AMENDMENT REPORT

Wellington North Solar Farm

March 2021

Project Number: 20-483

Figure 2-1 Updated proposal layout.

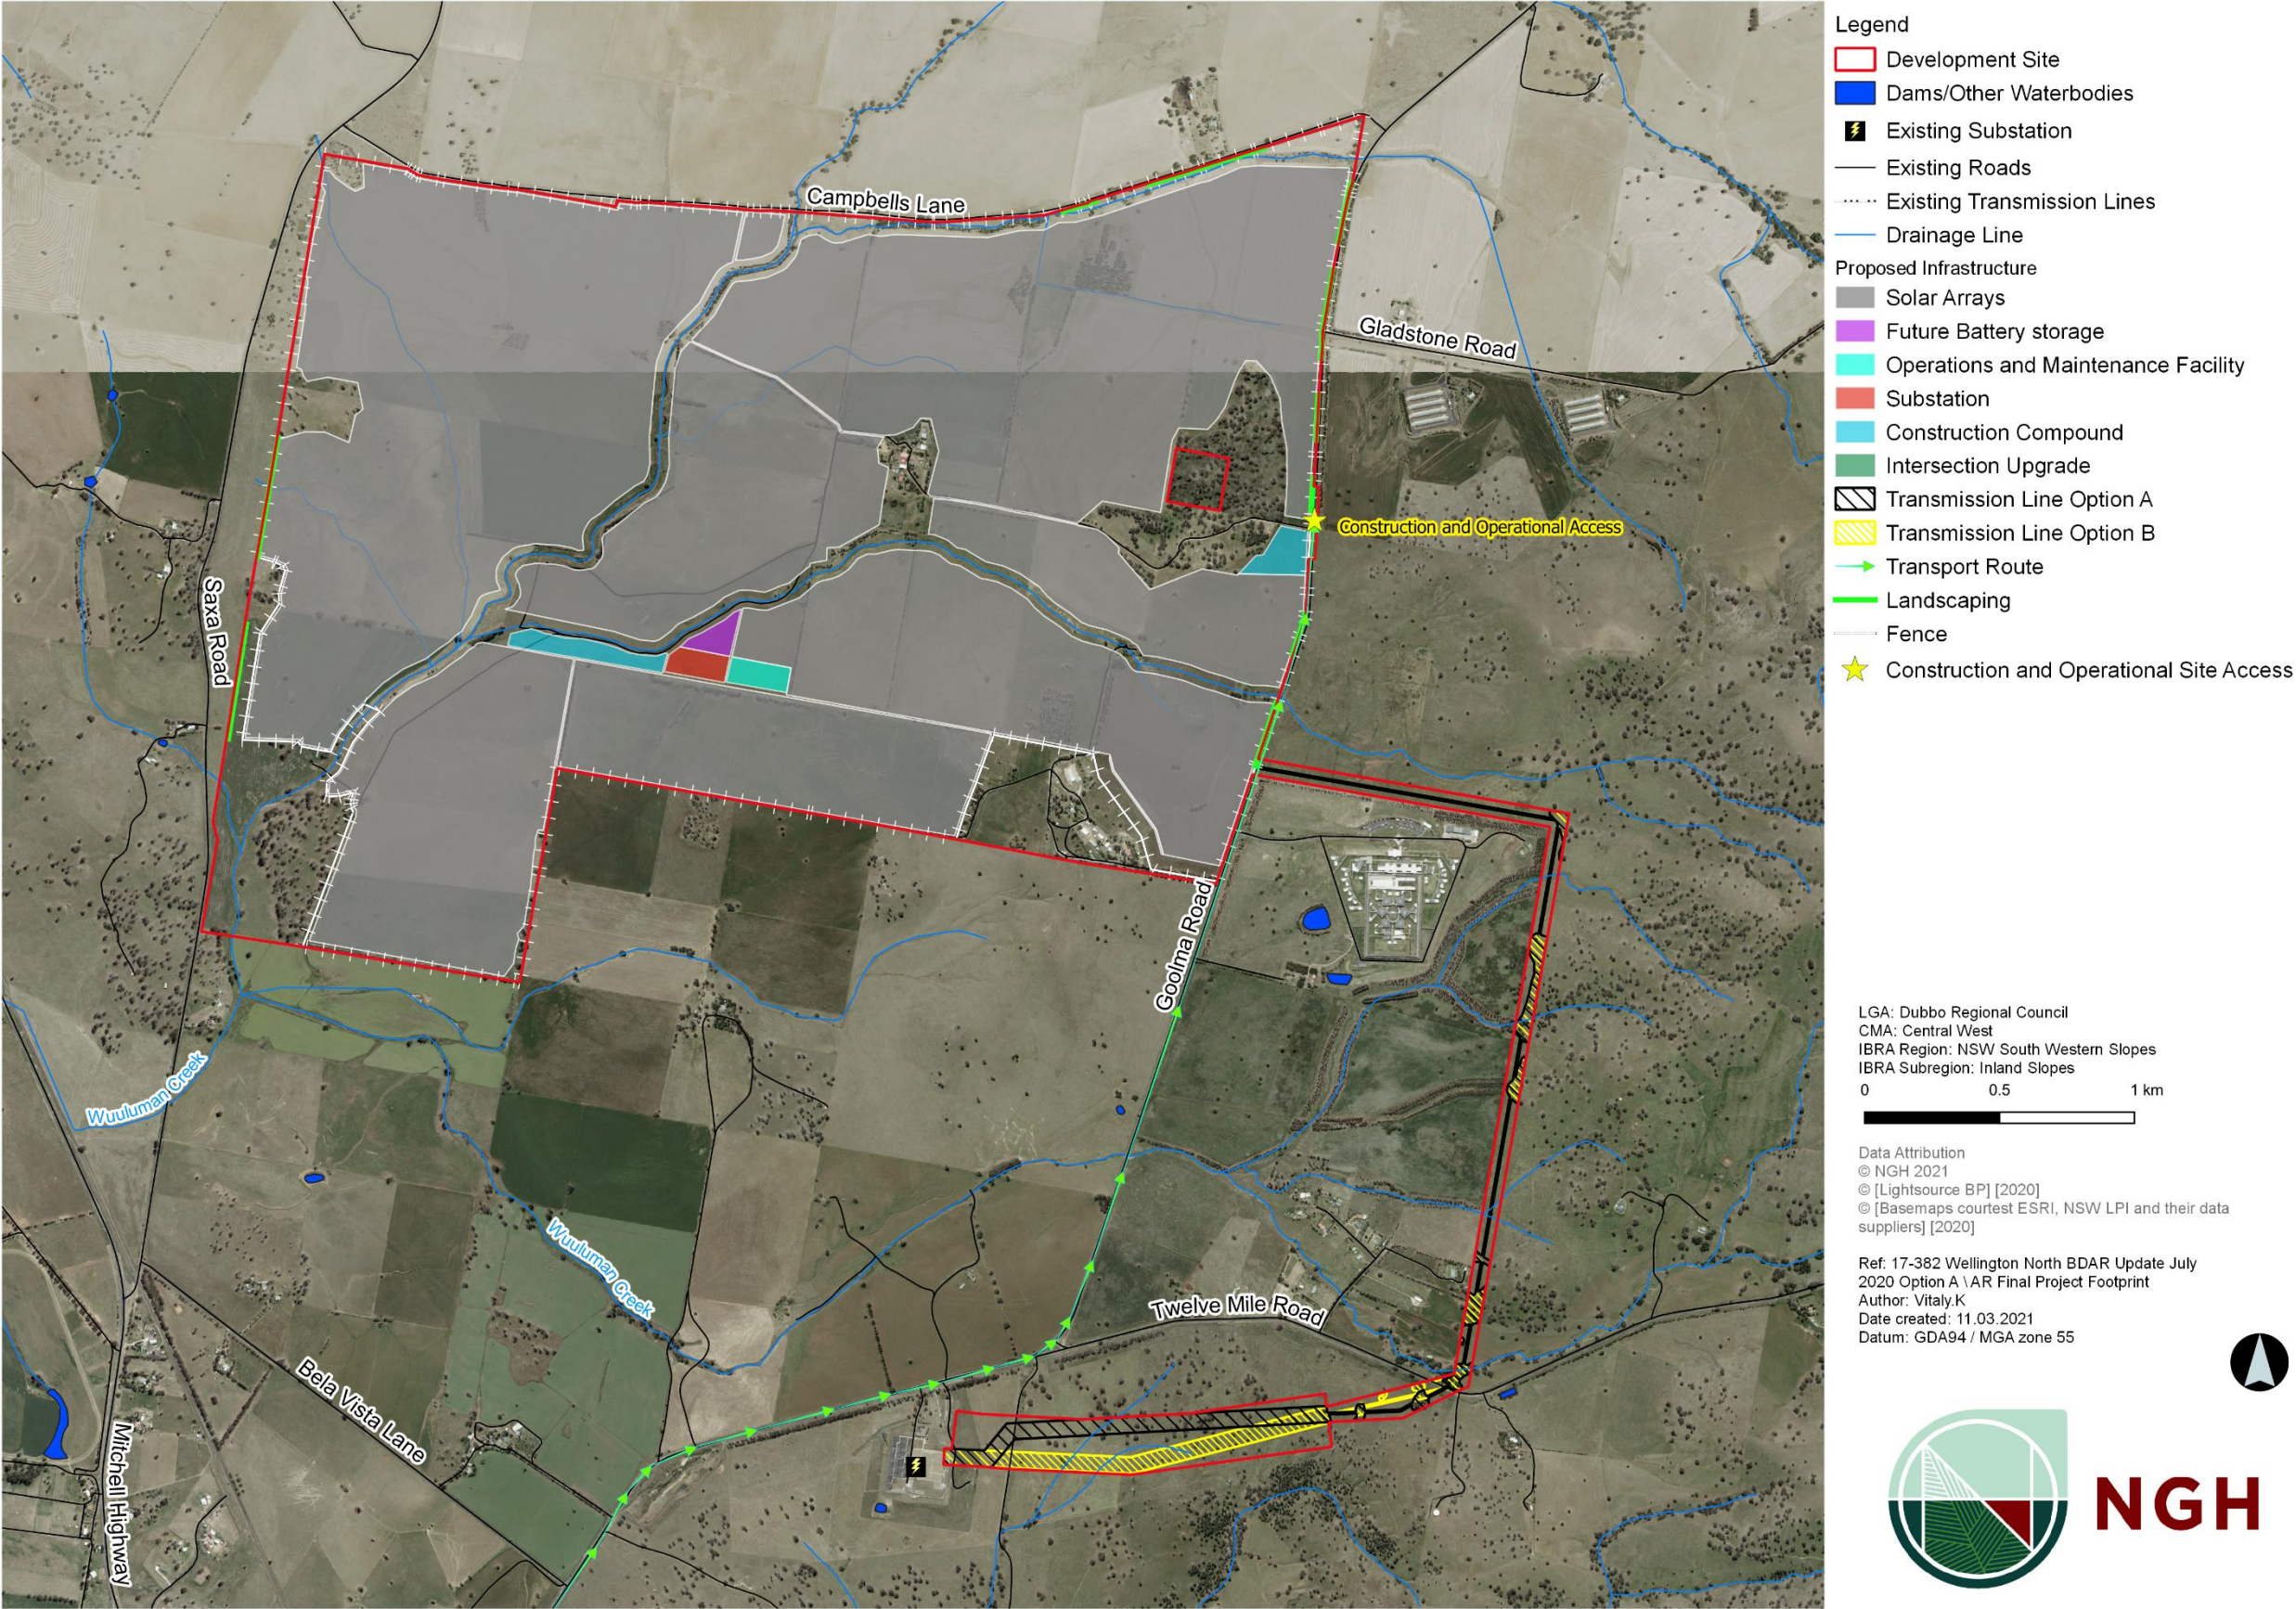
Two options for the development of the transmission line were described in the EIS, these were superseded by the 'new eastern transmission line' as described in the first Amendment Report (NGH, 2019). Lightsource bp has now proposed a change to this transmission line option. The justification for this is provided within Section 2.5 of this report. For this Amendment Report, the updated location for the transmission line relates to the southern portion of the transmission corridor, located within Lot 32 DP622471. The changes can be seen in the updated proposal layout and constraints map provided in Figure 2-1 and Figure 2-2. This portion is located between Twelve Mile Road and the Wellington Substation. The options for this portion include two overhead and/or underground routes for the 330kV transmission line (refer to Option A and Option B in Figure 2-1).

Near TransGrid's Wellington Substation the proposed new eastern transmission line may need to be located underground for a portion of the route, in order to avoid the relocation of existing transmission lines located within the proposed transmission line corridor (refer to Figure 2-1).

In the EIS there was a construction compound located near the construction site access point on Campbells Lane (Access Point 1). Given the proposed changes to the construction site access point, the Proponent now propose to relocate that construction compound to the entrance of the proposed new site access point on Goolma Road (Access Point 3). The updated location of this construction compound can be seen in the updated proposal layout and constraints map provided in Figure 2-1 and Figure 2-2.

Figure 2-3 Transport Route.

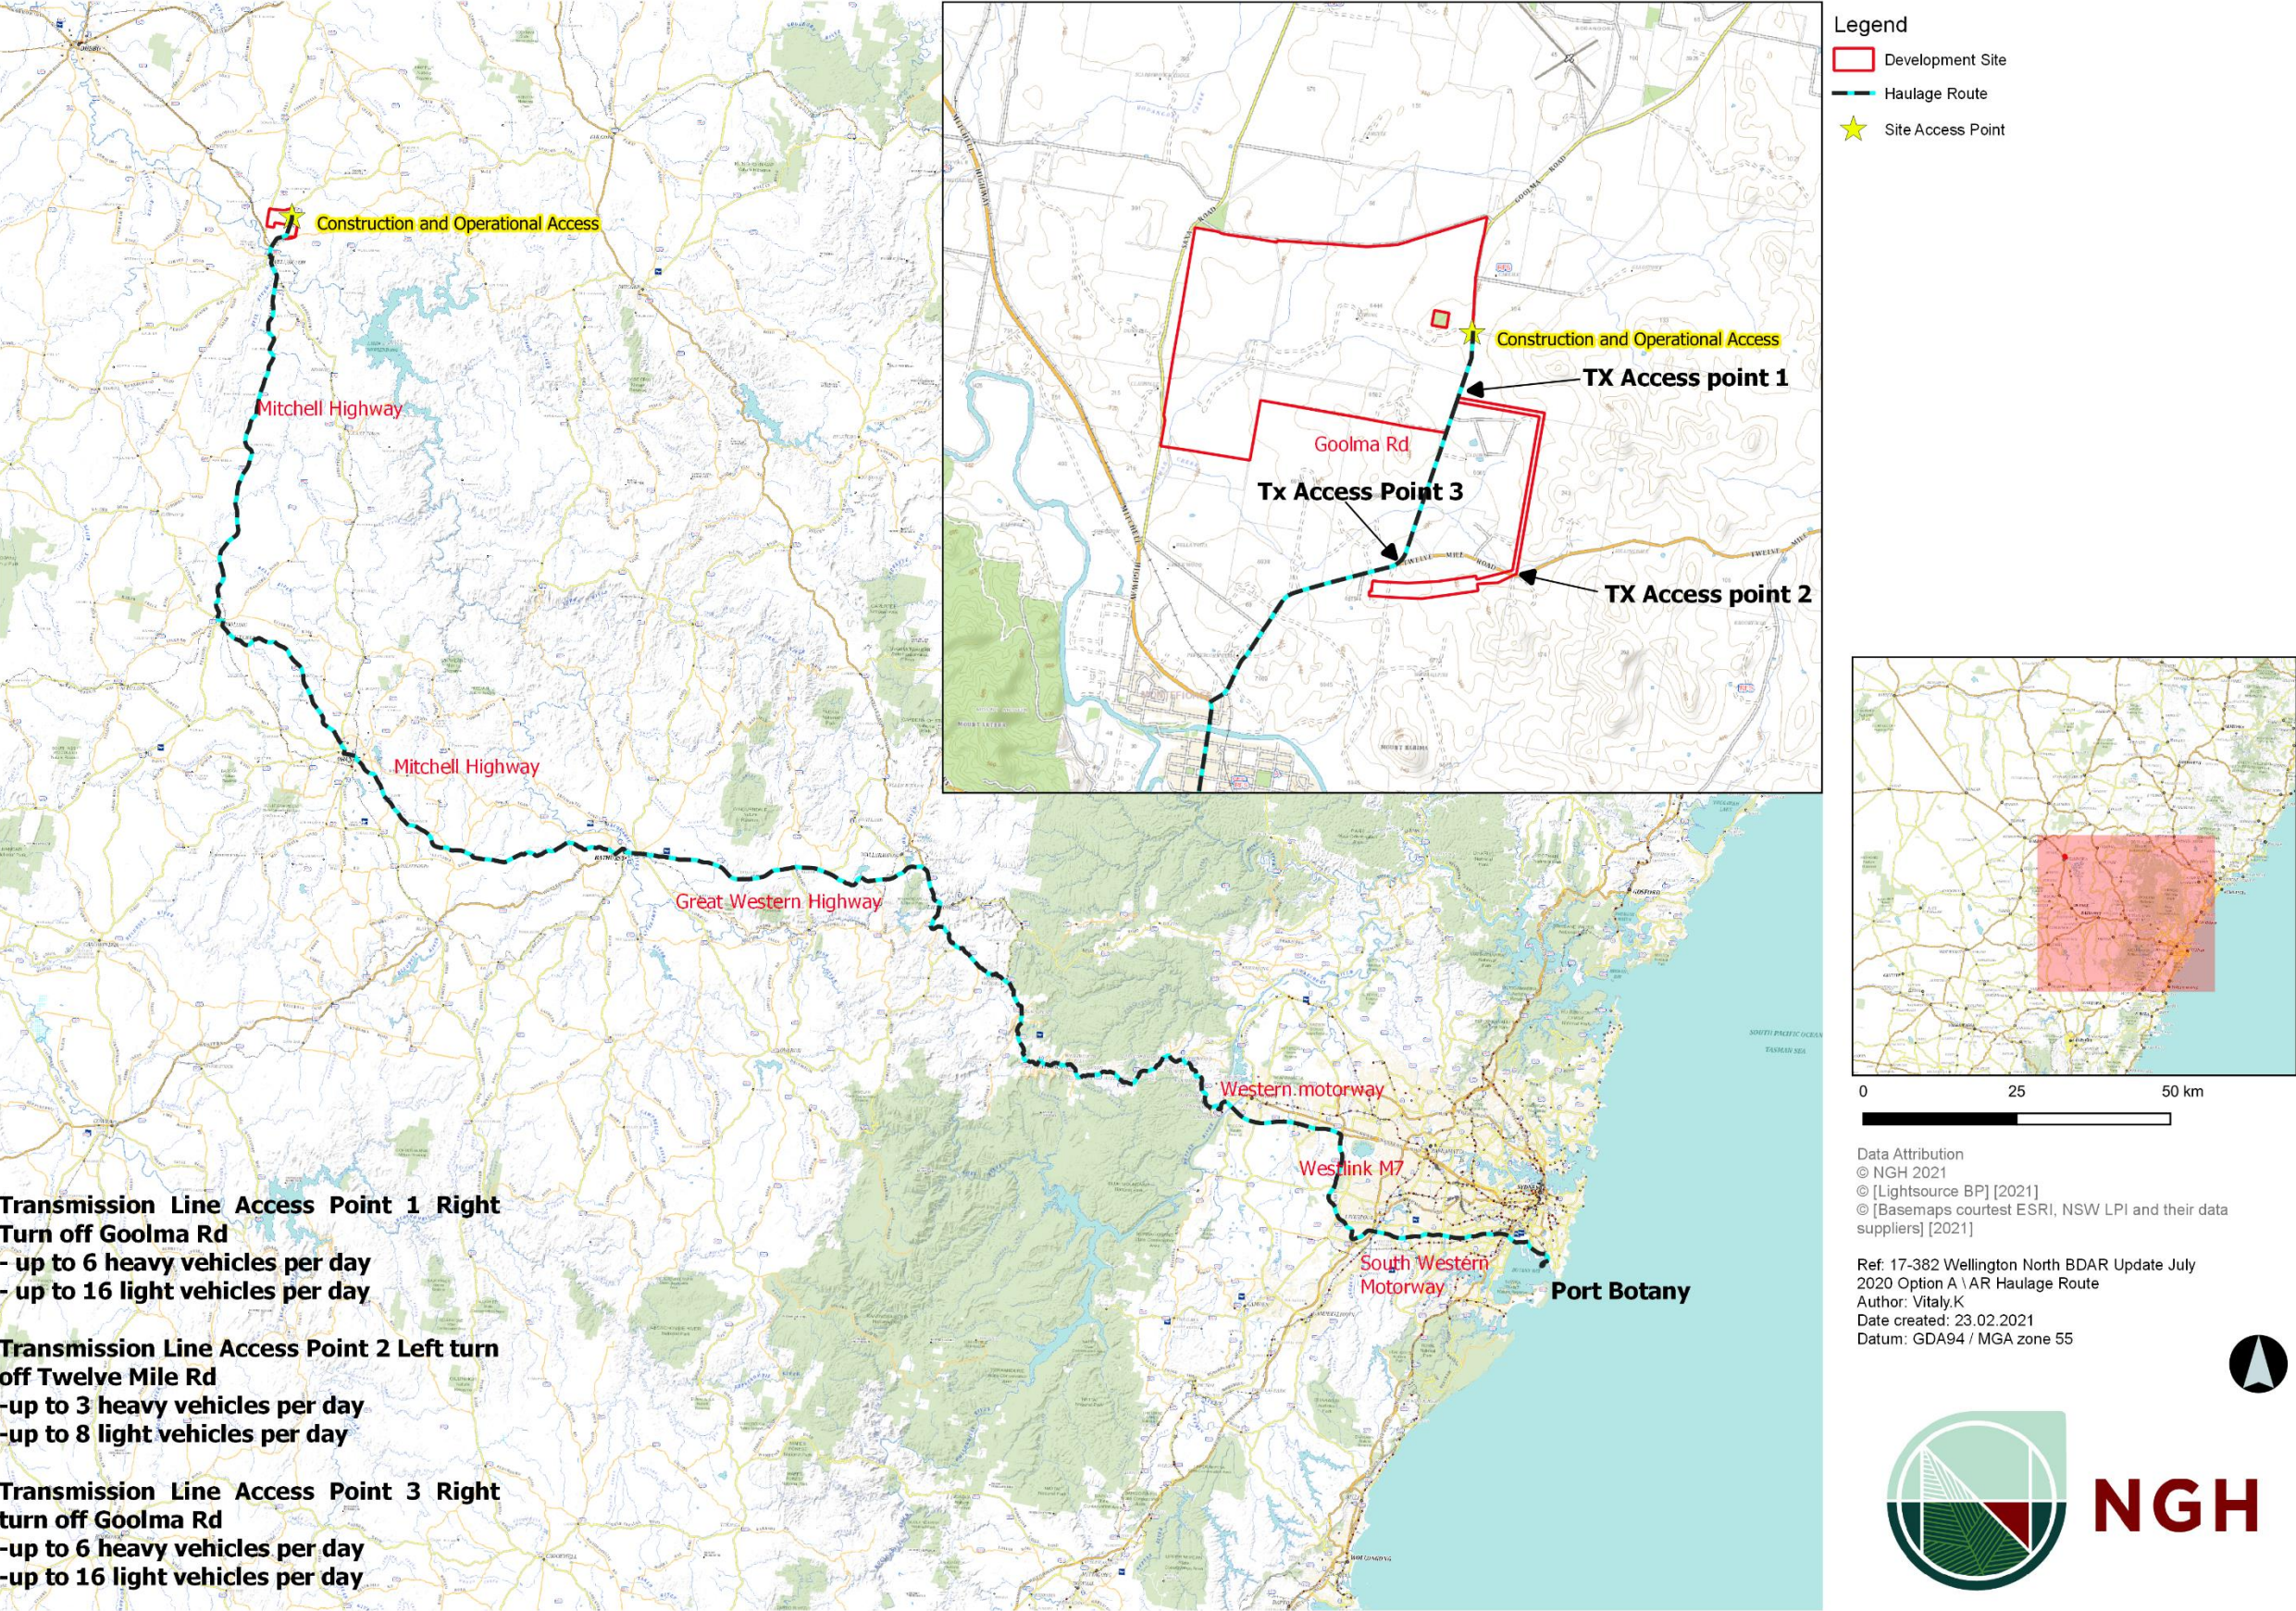
The EIS described the main vehicular access route to the Project site as being from Campbells Lane via Cobbora Road. Lightsource bp now proposes to access the Project site from the south via the Mitchell Highway and Goolma Road. Three site access options were described and assessed in the EIS and previous Amendment Report. The Proponent has now committed that all construction and operational site access would be via a single access point off Goolma Road. These changes can be seen in the updated proposal layout provided in Figure 2-1 and transport route map provided in Figure 2-3 and the justification for this is provided within Section 2.5 this report.

The EIS proposed the main transport route for construction materials would utilise Cobbora Road via the Golden Highway or the Mitchell Highway. Under this proposed amendment, all construction and operational access would be from the south via the Mitchell Highway and Goolma Road 40 metres north of the existing landowners driveway. The impacts of this change have been assessed in the updated *Traffic Impact Assessment* (GHD, 2021) and the Traffic Memorandum (GHD 2021). The updated Traffic Impact Assessment is summarised in Section 3.4 and provided in Appendix E. The Memorandum

Figure 3-14 AUL(S)/BAL turn treatments (GHD, 2020)

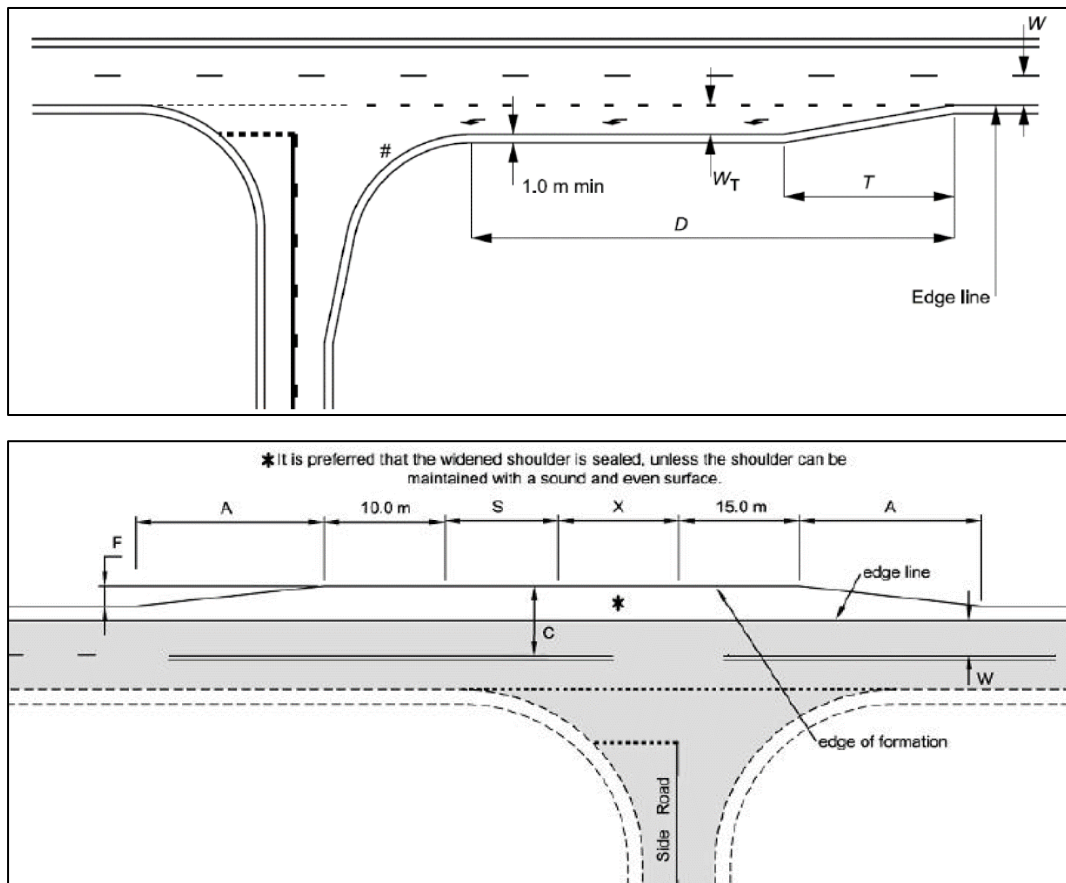
Based on the warrants, it is proposed that consideration could be given to the provision of a short auxiliary left turn lane (AUL(S)) from Goolma Road into the site (Figure 3-14). Although it is anticipated that all vehicles will be travelling to and from the south, incorporating shoulder widening on the eastern verge (i.e. BAR type treatment), would facilitate improved safety for southbound movement as well as facilitating the turn path of larger vehicles exiting the site, if required.

The treatments should be designed to accommodate articulated vehicles up to 19m in length (anticipated typical maximum vehicle length). Larger vehicles will require special permit and traffic management when required.
